Discussion of "Investigation of Flow Upstream of Orifices" by D. B. Bryant, A. A. Khan and N. M. Aziz, Journal of Hydraulic Engineering, January 1, 2008, Vol. 134, No. 1, pp. 98-104

Discussion of “Investigation of Flow Upstream of Orifices” by D. B. Bryant, A. A. Khan and N. M. Aziz

Gilles Belaud¹ and Xavier Litrico²

Figure 1: Definition of velocity components in a vertical plane ($x - z$)

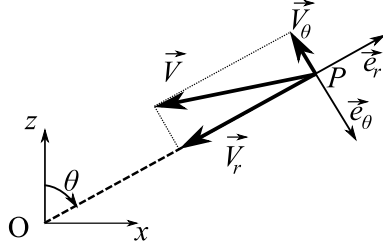
and $\vec{V} = V_r \vec{e}_r + V_\theta \vec{e}_\theta$. We recall in Figure 1 the definition of the radial and transverse velocities V_r and V_θ and the unit vectors \vec{e}_r and \vec{e}_θ .

Assuming that the potential depends only on r leads to assume that V_θ is zero, which in turn gives $V = |V_r|$. Note that V_r should be negative in the case of a sink.

In fact, it is not clear which quantity is displayed in the figures of the paper. The legend states V_r , i.e. the radial velocity, but the discussers think that the plot corresponding to the “new solution” and the experimental results in fact represent the velocity magnitude, while the “original solution” corresponds to the magnitude of the radial velocity.

Therefore, we think that the apparent discrepancy between the original and new solutions is due to a confusion between radial velocity and velocity magnitudes. Provided the origin of the polar coordinates is in the orifice, these two quantities are close to each other far from the orifice as pointed out by the authors, but largely deviate as we approach the orifice.

Figure 2: Velocity values along z coordinate at different distances x from the orifice plane.

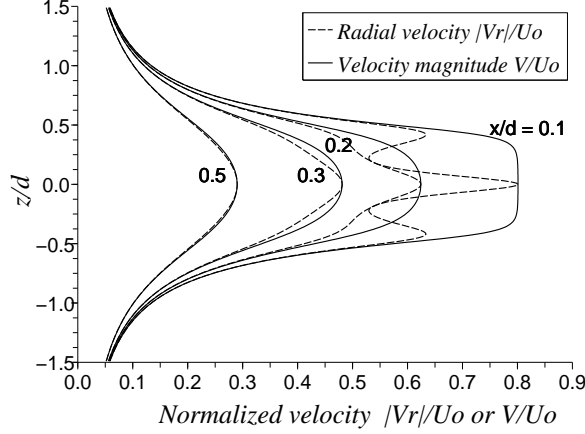
These velocities are plotted at different distances from the orifice in Figure 2. The distances are normalized by the equivalent diameter $d = 2\sqrt{4/\pi}c$ which gives the same area for the square orifice as for a circular orifice of diameter d . The plots are very similar to those of Bryant et al. (2008) (Fig. 4). In the paper, the radial velocity is calculated using the method of Shammaa

et al. (2005), while the solution presented as the “new solution” appears to be the velocity magnitude. Far from the orifice, the transverse component of the velocity becomes small and both quantities become very close. Figure 3 shows the iso-velocity lines in the plane $x - z$ and can be compared to Figure 3 of Bryant et al. (2008): the dotted lines depict the radial velocity V_r , while the plain lines depict the velocity magnitude. We can also point out that the orifice shape has little influence in the domain of study.

This inequality explains why, in Figures 3 and 4 of Bryant et al. (2008), the original solution is always lower than the so-called new solution, in which the velocity magnitude V is calculated from Eq. (12) of this discussion and Eqs. (5) to (7) of Bryant et al. (2008).
